7359 Wisconsin Avenue:  
Sketch Plan No. 320180070, Preliminary Plan No. 120180040, Site Plan No. 820180040

## Summary

- Staff recommends **Approval** of the Sketch Plan, Preliminary Plan, and Site Plan with conditions.
- The Applicant previously submitted a Concept Plan (520180010) for the proposed development for staff and agency review in July 2017. Comments were provided prior to this Application.

Figure 13 – Plaza Detail Showing Ramp Configuration

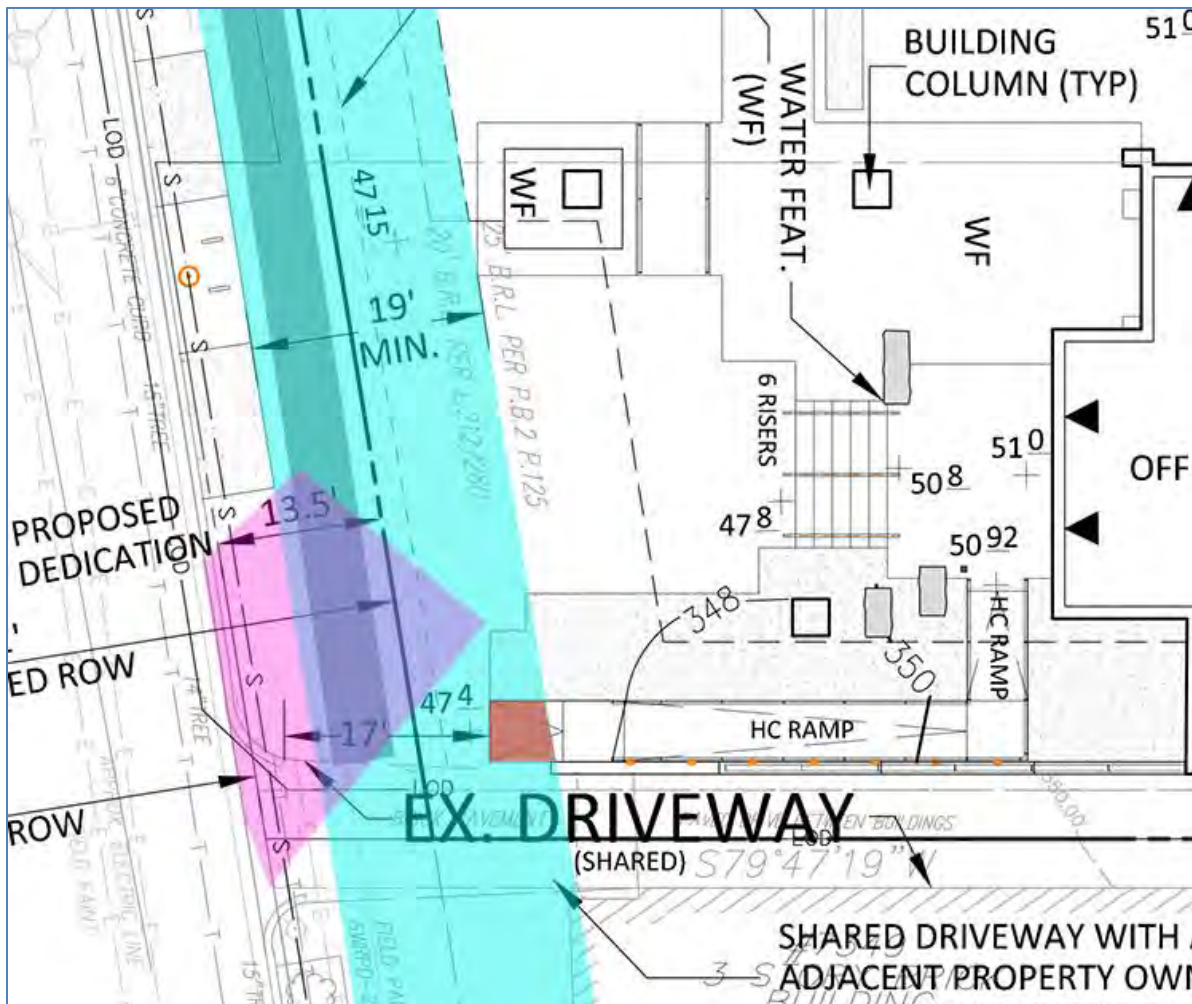
Consistent with the Sector Plan *Design Guidelines*, the Applicant is proposing a 19' minimum clear pedestrian path along Wisconsin Avenue. Given the prominence of the street and the elevated levels of pedestrian traffic expected by this development, including the innovative public art and plaza design, this wider clear path is an essential element of the success of the design, particularly in its relationship to the other properties along Wisconsin Avenue.

At issue is that the Applicant's design projects the handicapped accessibility ramp several feet into this pedestrian clear area. The ramp, and the central steps, are needed to access the main office entrance, as it is about 3.5 feet above the Wisconsin Avenue sidewalk. The building occupies the entire Montgomery Avenue portion of the block, and the ground floor grade is set at the hotel entrance on Montgomery Avenue, so the portion of the ground floor at Wisconsin Avenue is elevated.

Staff initially raised concerns about the location of the ramp at the time of the Concept Plan, and raised it again at DRC for this combined review. The current design could readily be modified to better integrate the accessibility ramp, providing for improved safety and a better visitor experience. Below are two potential alternative designs, each of which are based on the existing ramp dimensions. The first alternative slides the lower ramp landing toward the building while rotating the final run of the ramp into the office entry procession space, in line with the proposed bridge. The bench is relocated adjacent to the Wisconsin Avenue sidewalk and a small landscape bed covers the transition. The second alternative more rotates the final ramp run to the north side of the lower landing in its current location, bringing the ramp into the space at the transition area between the sidewalk and the plaza, keeping more of the seating facing into the plaza at the base of the stairs.

- e. The Applicant must remove the handicap access ramp on Wisconsin Avenue from the clear Pedestrian Through Zone.

Figure 15 – Ramp Alternative 2

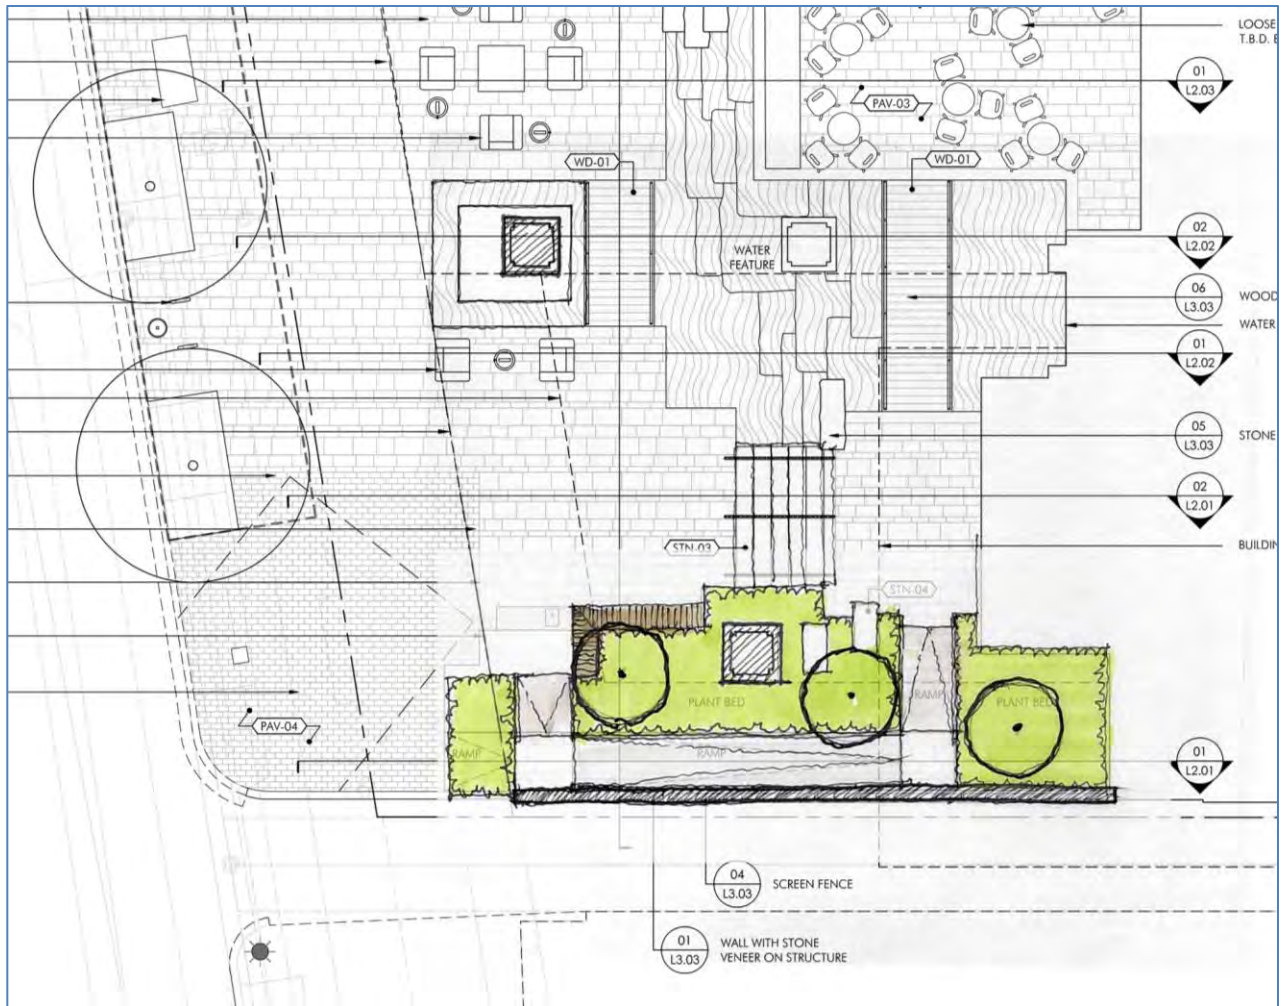
The second alternative more rotates the final ramp run to the north side of the lower landing in its current location, bringing the ramp into the space at the transition area between the sidewalk and the plaza, keeping more of the seating facing into the plaza at the base of the stairs.

These are but two potential alternatives, but both better integrate the ramp into the plaza space while not requiring people using the ramp from coming out in the middle of the busy Wisconsin Avenue sidewalk, the Fire Department Emergency Access area, and next to a vehicular driveway. Staff has included in the recommended conditions of approval a requirement that the ramp be removed from the pedestrian clear zone. The Certified Site Plan can illustrate the new design.

Figure 22: Waverly Street Loading Detail

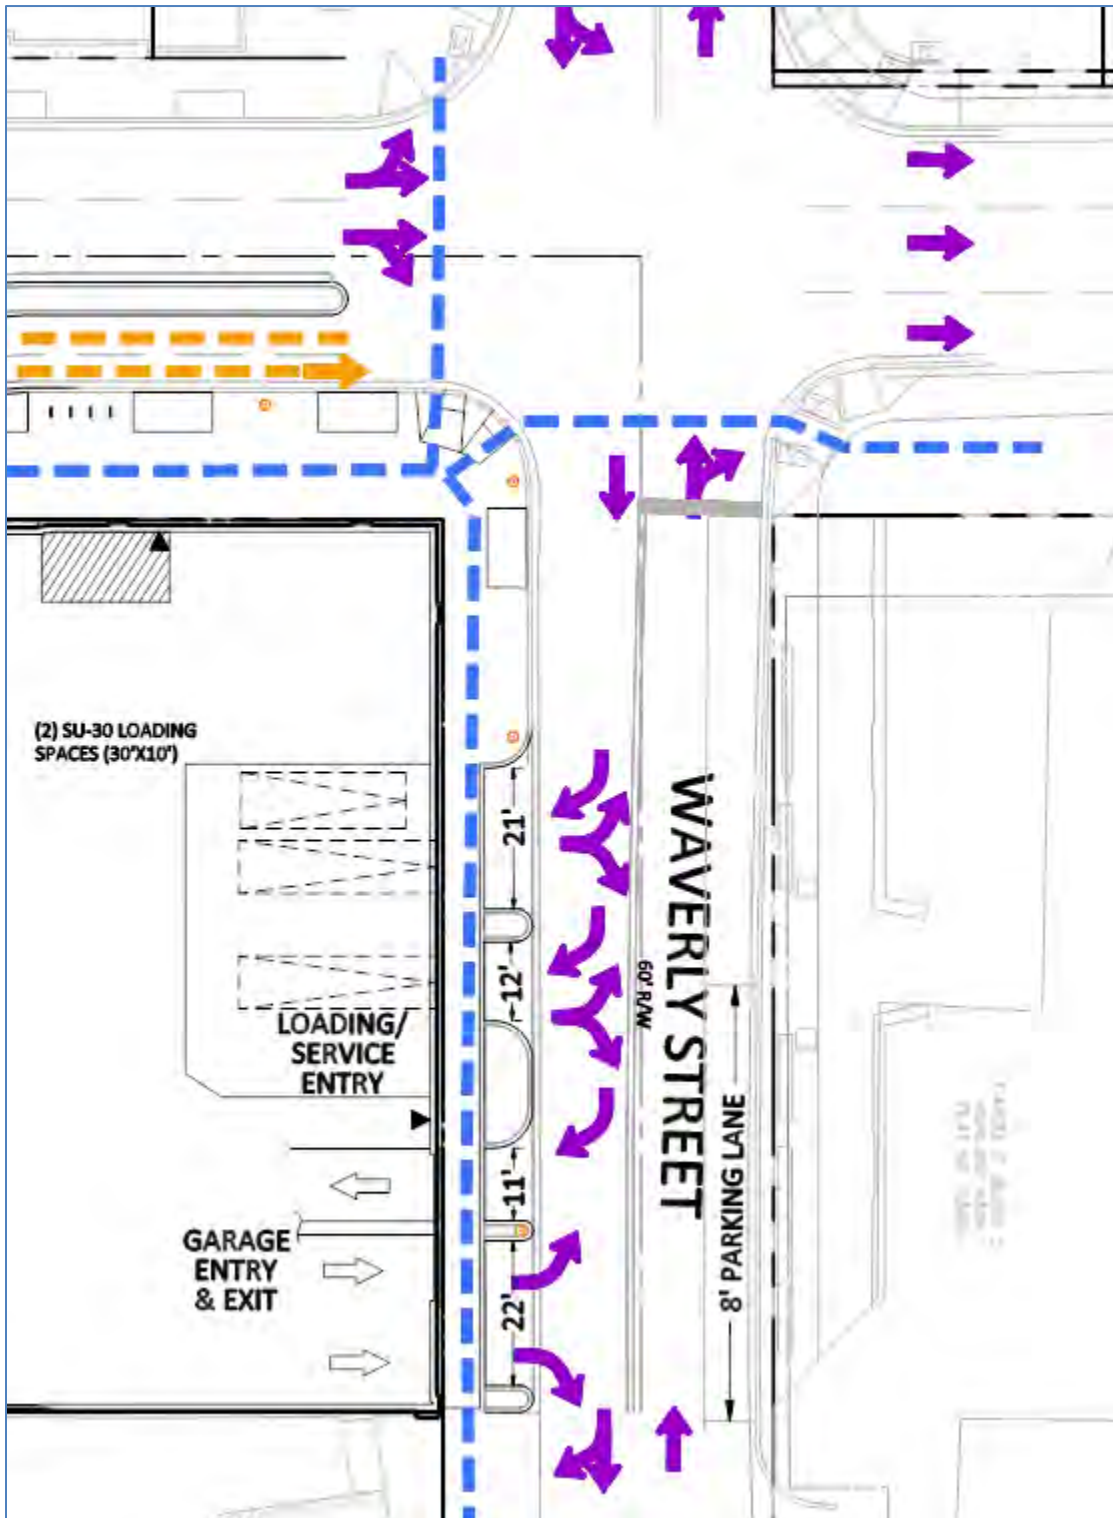
The Project's Waverly Street façade measures 133'. As proposed, 92' (69%) is dedicated to vehicular access points. Of that 92', 35.5' (27% of the Waverly Street frontage) is specifically dedicated to garage ingress/ egress with the remaining 56.5' (42%) allocated to loading/ service. As conditioned, the garage access will be narrowed to a maximum of 24' (18% of the total Waverly Frontage), resulting in a total of 80' (60%) allocated to vehicular access points. This modification would enhance pedestrian safety by limiting pedestrians' exposure to potential conflict

points and reinforce the multi-modal nature of the Bethesda Downtown area. Furthermore, this modification constrains outbound vehicular turning movements, creating a stronger yield condition as cars cross the sidewalk and enter the Waverly Street travel way.

In response to Staff's request, the Applicant asserted that two outbound travel lanes are necessary for efficient garage operations and to reduce delay for those wishing to exit the Site by car. While a second outbound lane would increase the efficiency of garage egress, it would do so to the detriment of the pedestrian realm by increasing the number of potential vehicle movements and increase the potential for conflict between cars exiting the garage and cars traveling on Waverly Street, as well as pedestrians, and bicyclists.
